# PONTIAC

## Service Craftsman News

No. 4 S-271

April, 1955

Fig. 1 Rear Quarter Outer Panel Weld  
(Convertible Style Shown)

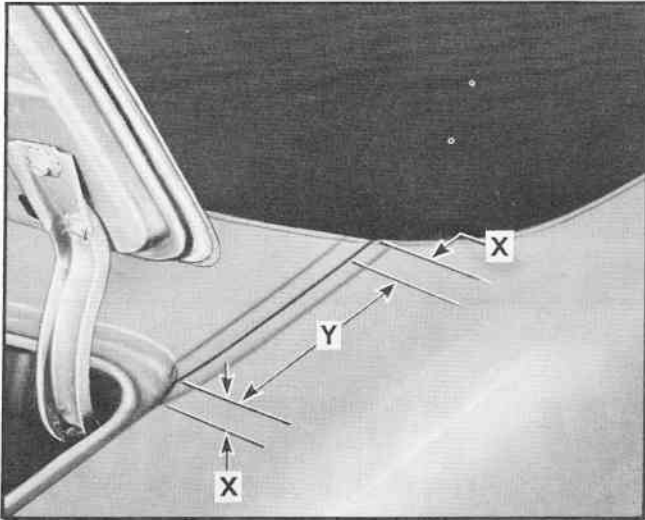
If a case is encountered where the solder fill on the rear compartment front and shelf panel to rear quarter outer panel and/or the rear end panel to rear quarter side outer panel extension is cracked, the condition may be corrected in the following manner:

1. If one of the rear compartment front and shelf panel to rear quarter outer panel weld joints is affected, remove the back window and all moldings necessary to gain access to the entire weld joint as shown in Fig. 1.

2. Protect all adjacent trim, hardware and painted surfaces against molten solder and the succeeding welding and brazing operations.
3. Remove all of the solder fill from the joint as shown in Fig. 1.

4. Protect the surfaces adjacent to the weld joint from distortion, using a wet asbestos paste.
5. Gas weld for a distance of one inch at each end of the joint shown by distance "X" in Fig. 1.
6. Braze the remaining weld joint as shown by distance "Y" in Fig. 1.

Fig. 2 Rear End Panel Weld

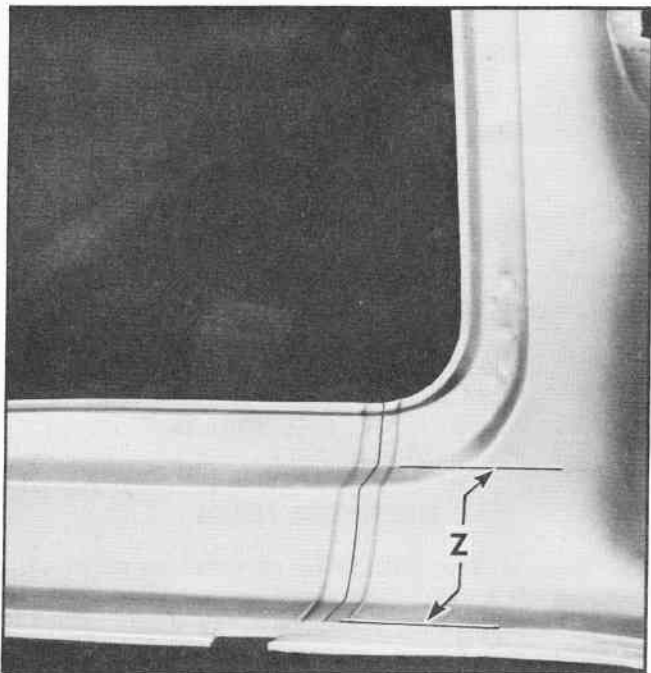
7. If the rear end panel to rear quarter side outer panel extension weld joint is affected, remove the solder fill and braze the joint as shown by distance "Z" in Fig. 2.
8. On all repaired weld joints: solder fill, metal finish and refinish after the brazing operation.

Fig. 3 Comparison of Three Valve Lifter Types

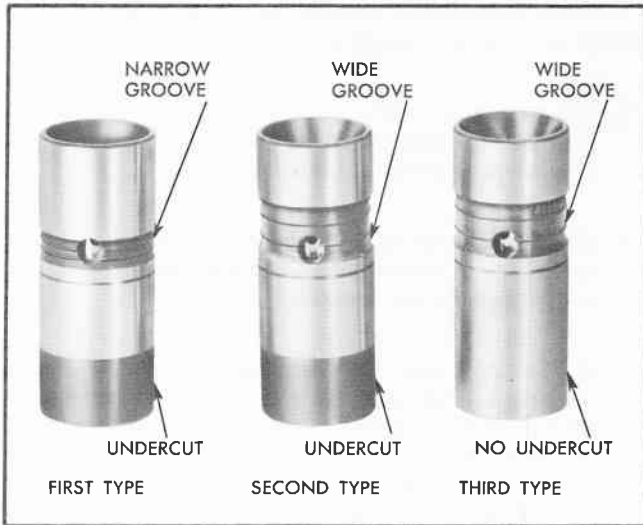
Since the beginning of production three type valve lifters, which differ in appearance, have been used. These three types are shown in Fig. 3. The first type has a narrow-groove and an undercut, the second type a wide groove and an undercut and the third type a wide groove with no undercut. These three types are interchangeable in all respects and are serviced under the same part number.
